ADDENDUM NO. 6

DATE: December 9, 2015

Contract 16-C-00007; Wayne C. Papy Center Renovations

A 8.1

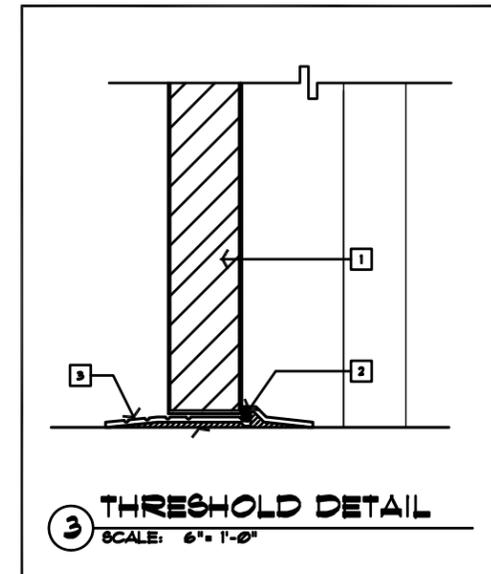
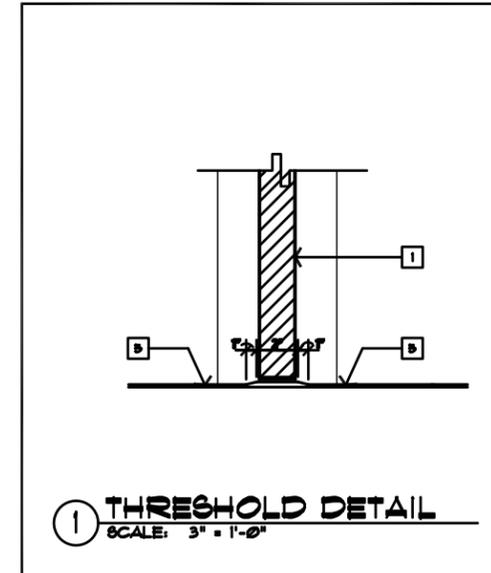
Item 2: Sheet A8.1, Window Type A1 Clarification: Glazing shall be Impact Resistant.
